Airports Commission shortlisted options  
Module 14: Operational Efficiency  
preliminary safety review

**CAP 1215**

**Figure 1:** Gatwick Control Area (CTR)

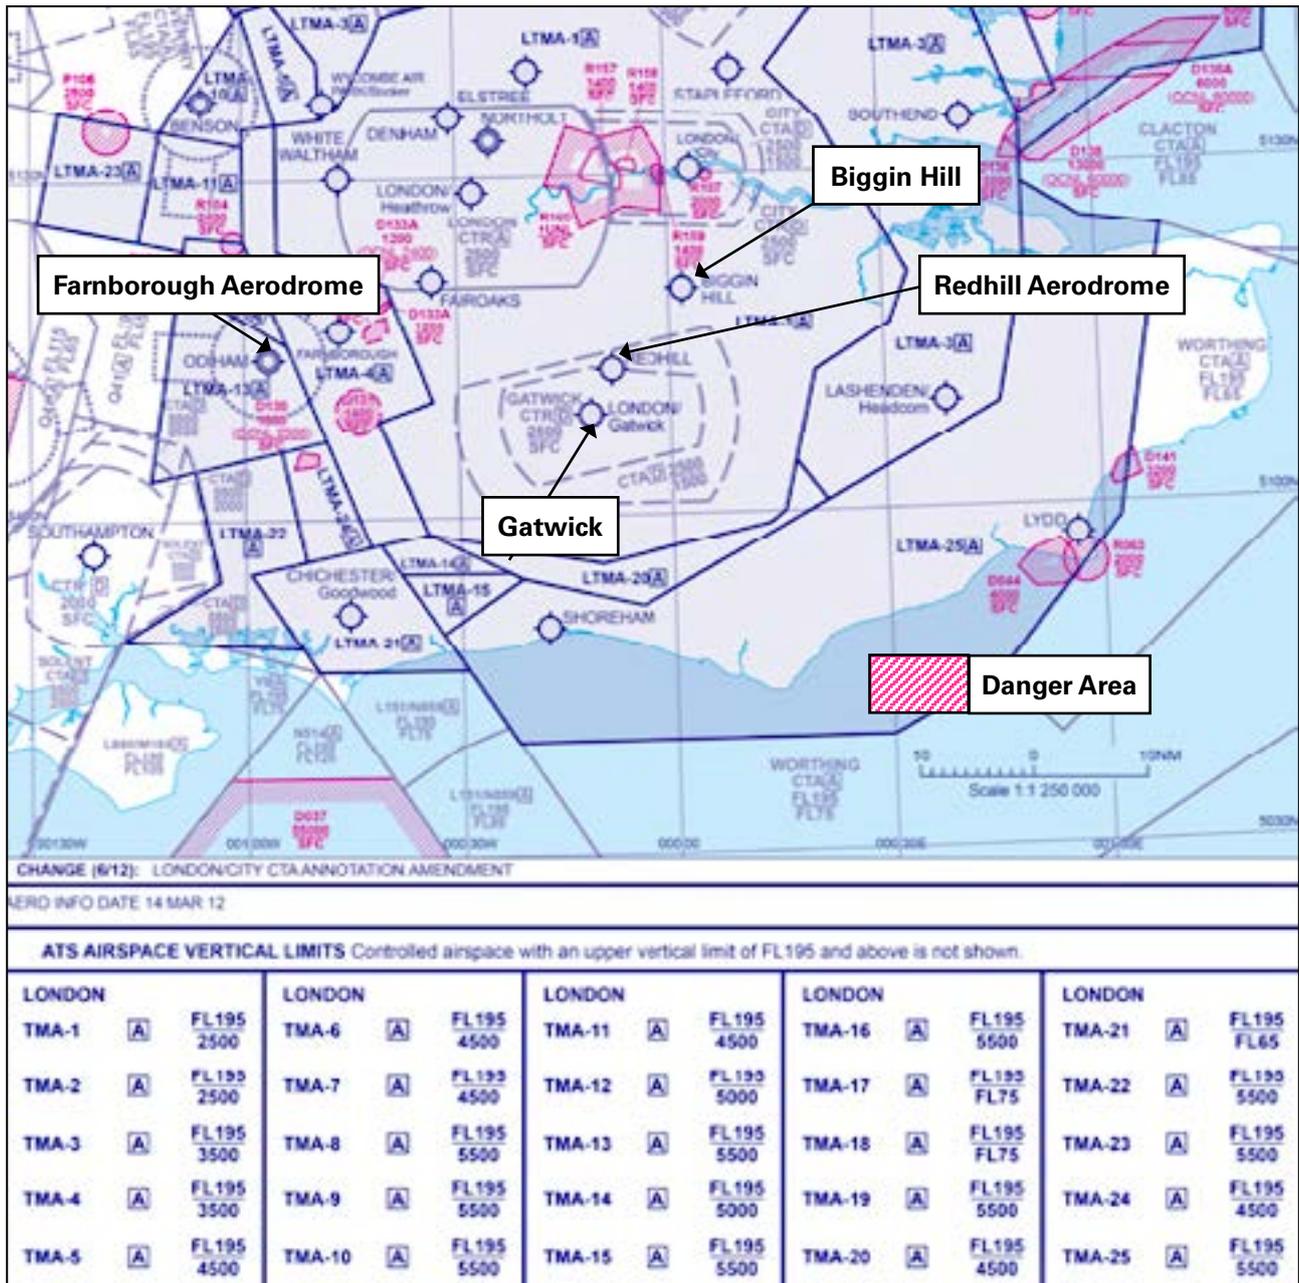
- 2.8 Gatwick is on the Southside of the London Terminal Manoeuvring Area and is sufficiently displaced to the south of Heathrow to have a relatively lower impact on other aerodrome procedures and knock on effects to other airports.

- 2.9 Standard Instrument Departure Routes (SIDs) would need to be redesigned to avoid conflicts associated with having two runways providing arrivals and departures. However, the position of the runways and a compass departure operation is unlikely to be a significant challenge. There is a potential issue of standard arrival routes (STARs) to parallel runways and the transitions flown, with potential for confusion if runway alternation (or Terminal arrivals) is likely to be a feature of the operation - if the existing runway is always the arrival runway this is less of an issue as arriving aircraft would not be required to cross in the air.

2.10 Farnborough aerodrome is currently in the process of developing new procedures and has just completed consultation on a new airspace design. The outcome of this is not yet determined. With revisions to arrival and departure procedures for an expanded Gatwick, there could be requirements for some additional controlled airspace to the west. Until designs are formalised, it is not possible to determine what impact, if any, new Gatwick procedures would have on Farnborough operations. Operations at Shoreham (south of Gatwick) are unlikely to be affected. Redhill (north of Gatwick) and Biggin Hill (north of Gatwick) are unlikely to be affected.

**Figure 2:** Heathrow Control Area (CTR)

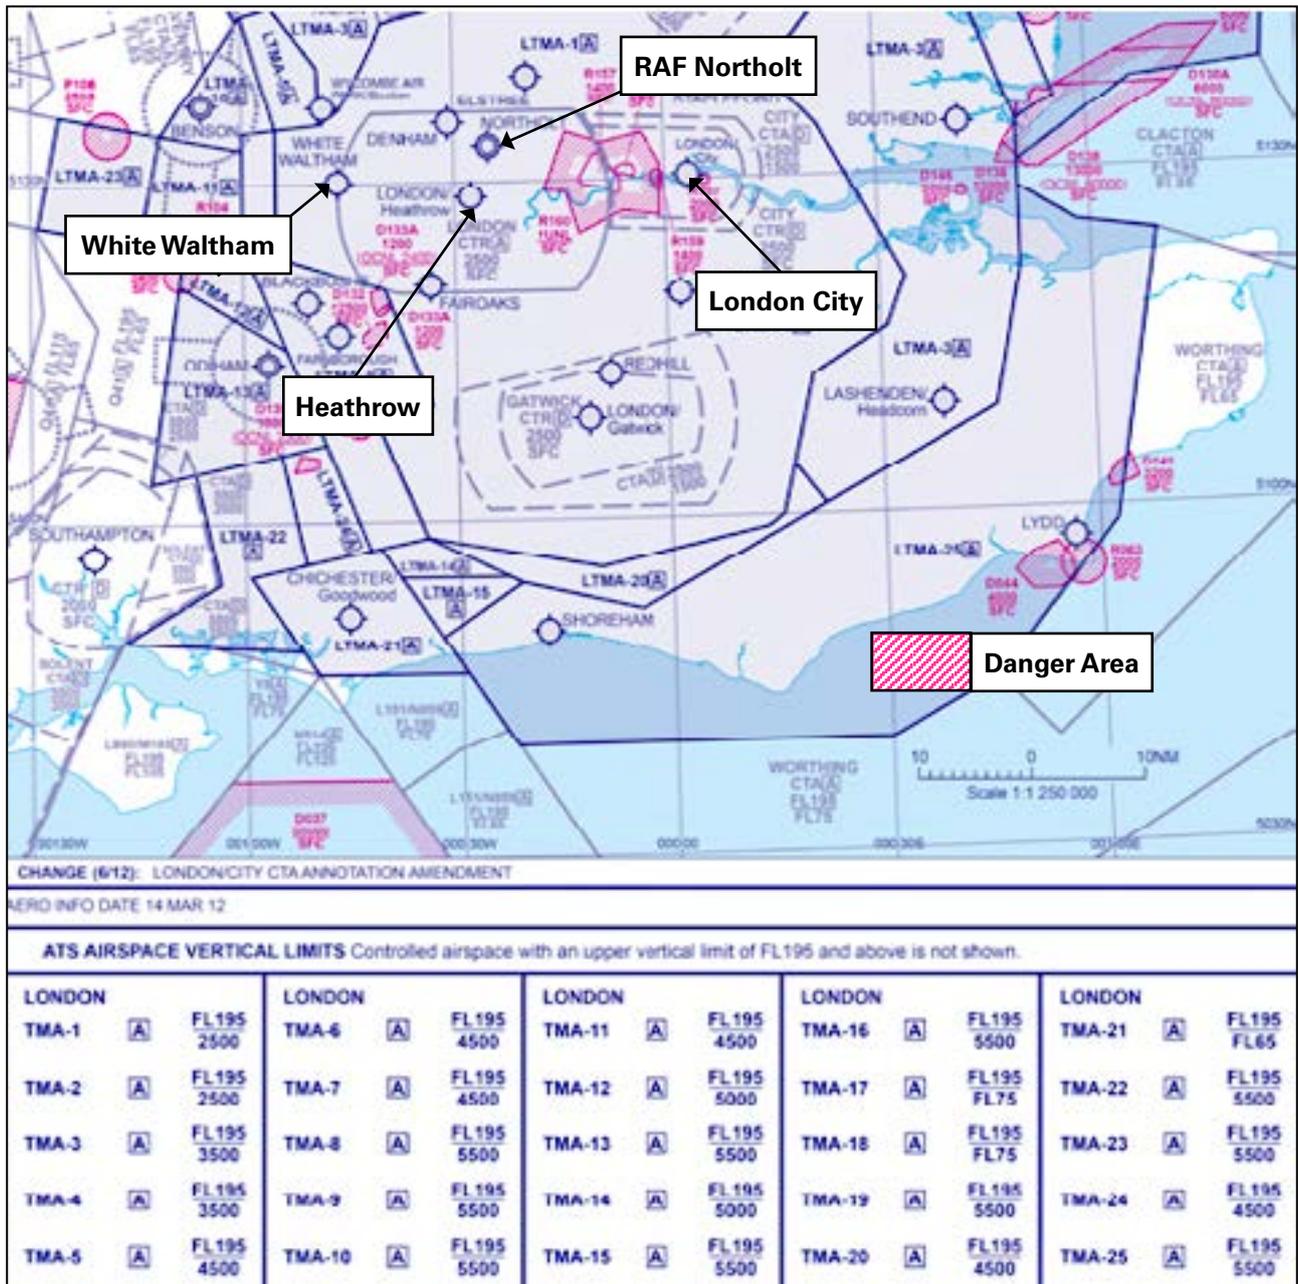
- 2.22 There is currently a lack of detail available at this early stage regarding airspace designs. However, an initial informal assessment of some of the impacts is provided below.
- 2.23 The design is likely to require a dependency with RAF Northolt to ensure safe separations, which could reduce capacity at either or both airports. Any impacts on RAF Northolt procedures need to be understood and assessed.
- 2.24 Missed Approach Procedures for both Heathrow and RAF Northolt remain a major design issue and a major challenge to deliver a safe and operationally effective environment due to close proximity of RAF Northolt and its runway axis (25/07).

2.25 SIDs would need to be redesigned to avoid conflicts associated with having two runways providing departures and the issue of the third runway being further west. It is unclear whether further controlled airspace to the western extremity of the Heathrow CTR is required to accommodate both arrival and departures for the proposal. The impact (if any) on operations at White Waltham and Denham aerodromes is unclear given that flight path vertical profiles are unknown at this stage. The impact on London City operations is also unclear as precise arrival and departure flight paths are unknown at this stage.
